CITY OF STAMFORD

INTEROFFICE MEMORANDUM

Subject:

**1911 Summer Street - KCI Summer, LLC
Zoning Application No. 223-39, 223-40**

PREPARED FOR:
DANIEL KOLICH
1911 Summer Street, Stamford, CT 06905
(Tax ID: 00-15245)
PROPOSED SITE PLAN
SP-1

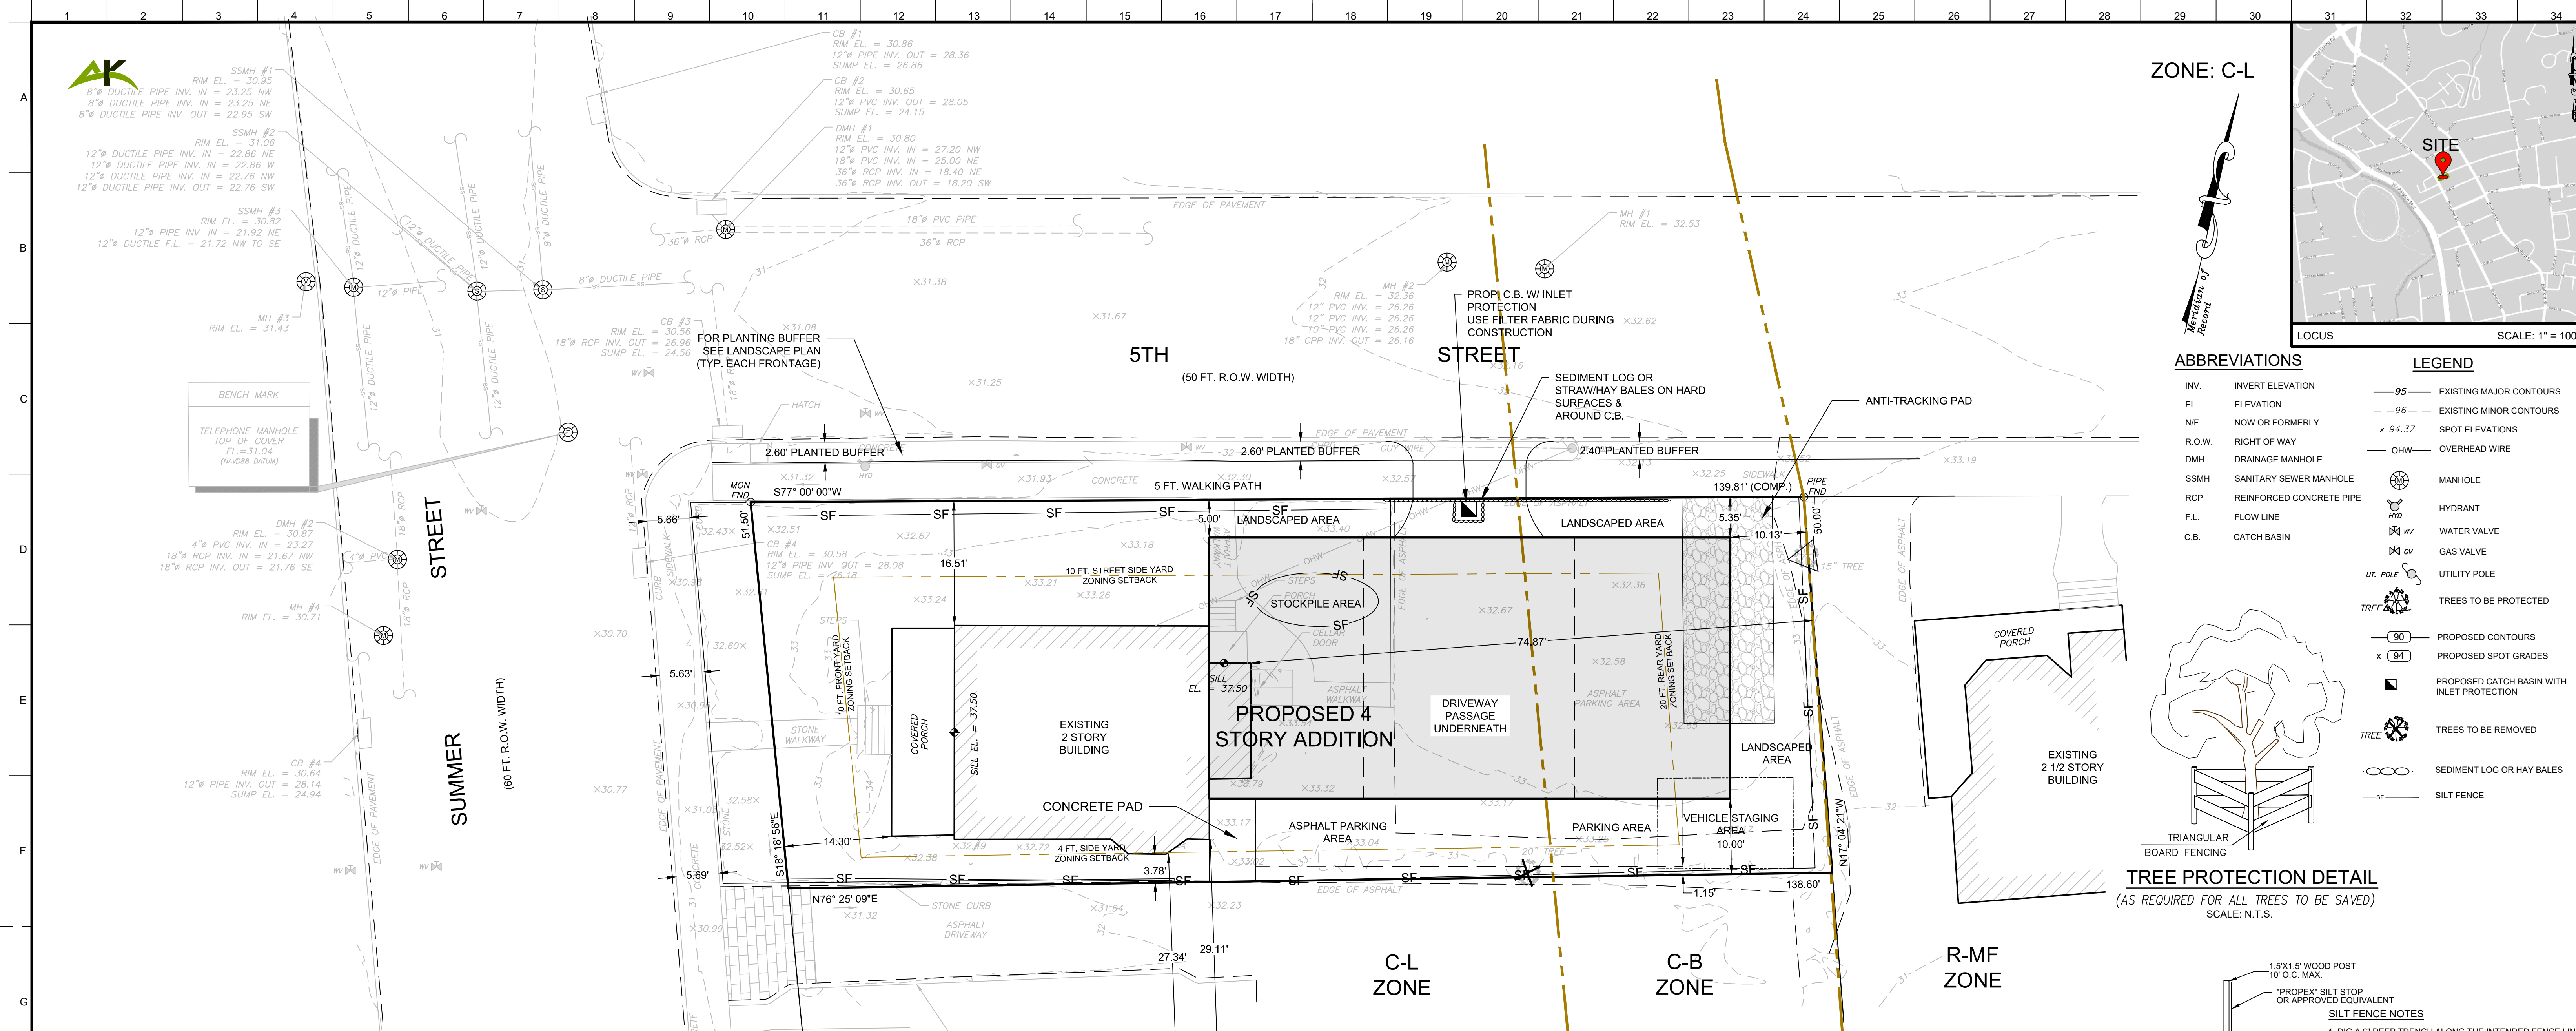
2) Connections to the City storm system must be via manhole and a Storm Sewer Connection Waiver will be

required. Revised the plan to connect to the manhole on 5th St. Storm Sewer Waiver will be submitted

- B) The Stormwater Management Report states that 3 catch basins will collect the parking lot drainage, however, only 1 catch basin is shown on the Site Plan. Clarify and clearly show proposed contours. There is one as shown on site plan

- G) The symbols for tree protection and tree removal are too similar. It appears that the triangle on the east property line and the X on the south property line identify tree protection and tree removal. Clarify. Yes. Triangle is protection and X is removal

SE-1

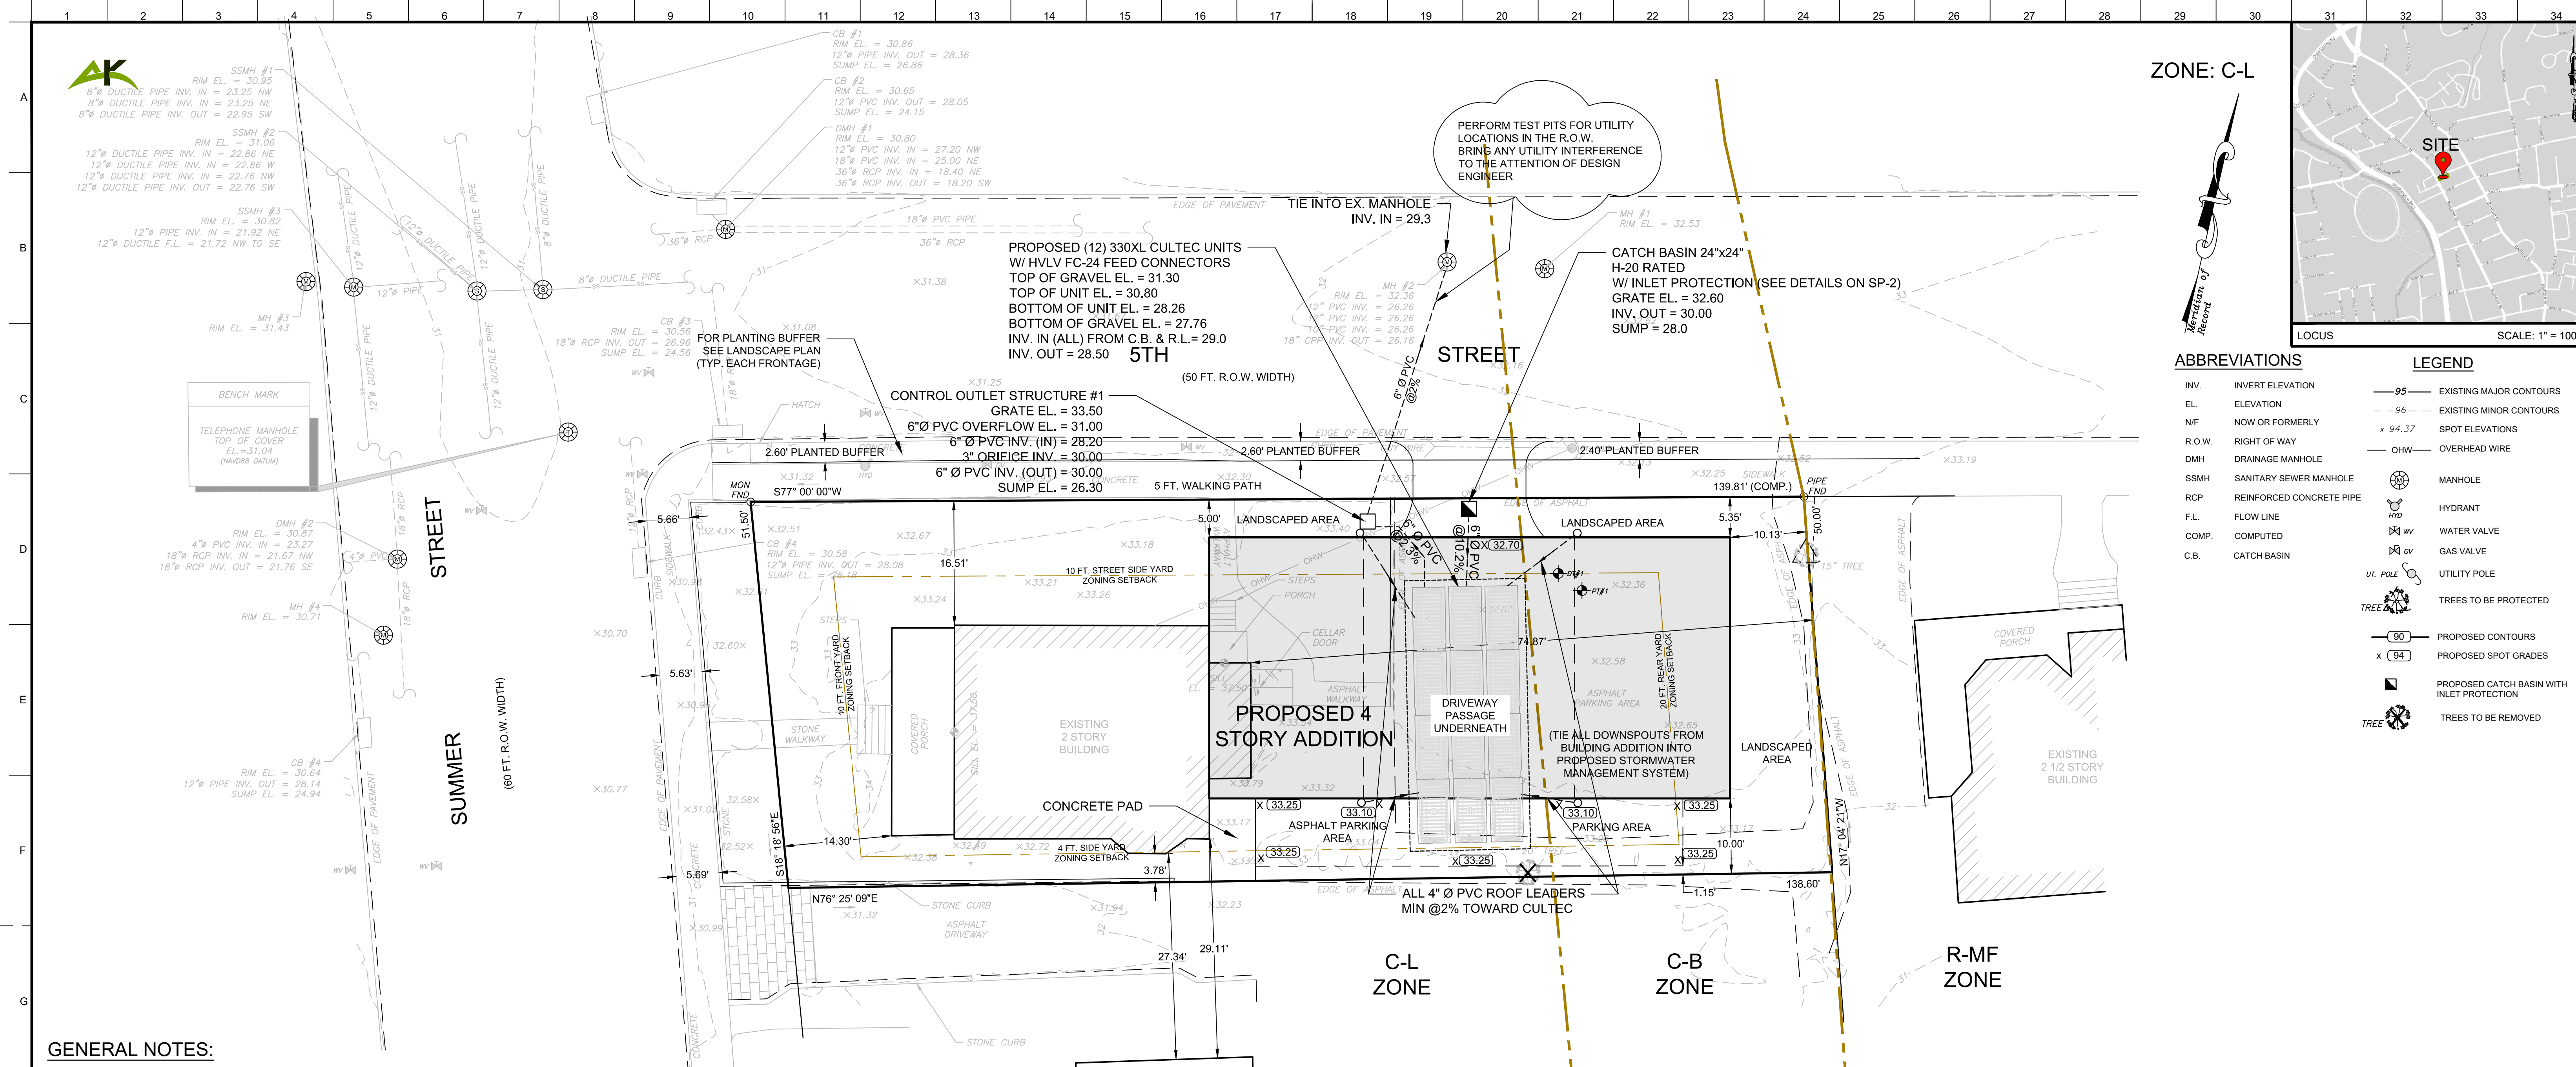
- 17) Extend the length of the anti-tracking pad. Extended to be 30' in length
- 19) A Drainage Maintenance Agreement will be required. Drainage Maintenance Agreement will be submitted

- A) Provide additional plan sheet(s) to clearly show the utility and drainage information, erosion and sediment controls and other site information, as well as all 4 proposed townhouses. S&E plan and site plan have been separated. Refer to architectural drawing

CULTEC RECHARGER 330XLHD

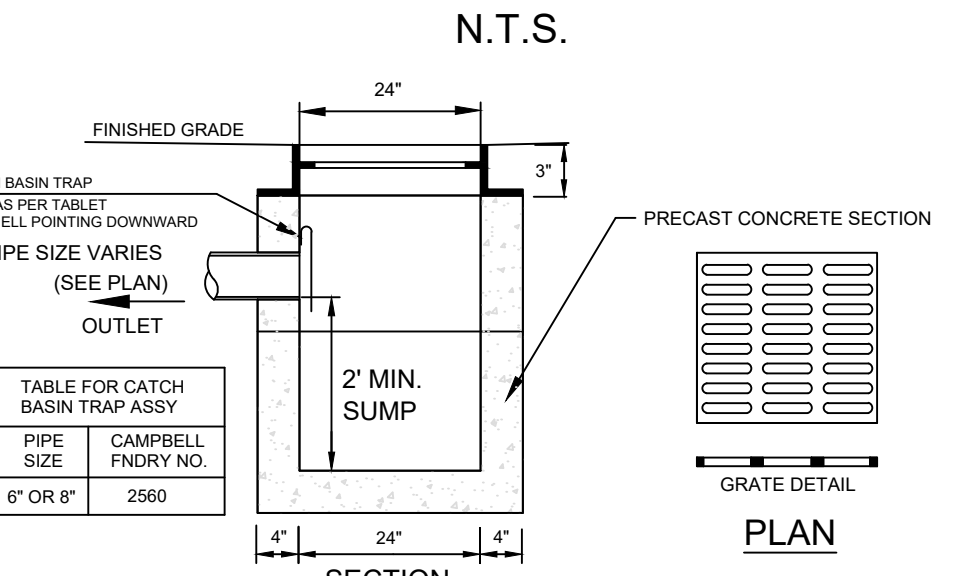
- C) Provide a permanent insert for CB #1 for Water Quality improvement. AbTech details added
- D) Eliminate the 90 degree bend in the pipe from the infiltration system to the outlet control structure. The maximum allowable bend is 45 degrees, unless there is a structure at the bend. Replaced 90° bend with two 45° with a short segment of PVC

N) Show all pipe connections to the infiltration system.

PERCAST CONCRETE CATCH BASIN (CB) N.T.S.

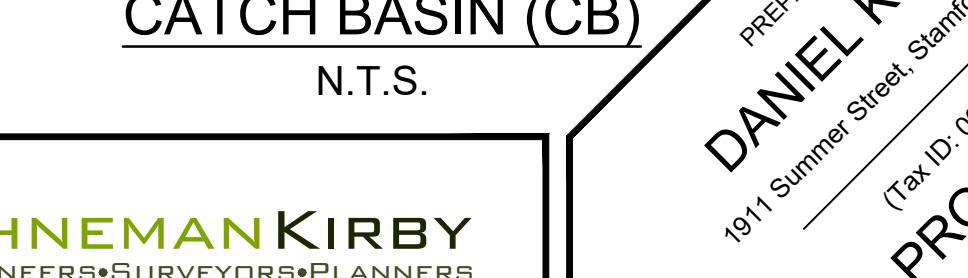
K) Catch basins in parking lot areas must be H2O load rated. Add this to the detail. **Added to the callout & detail**
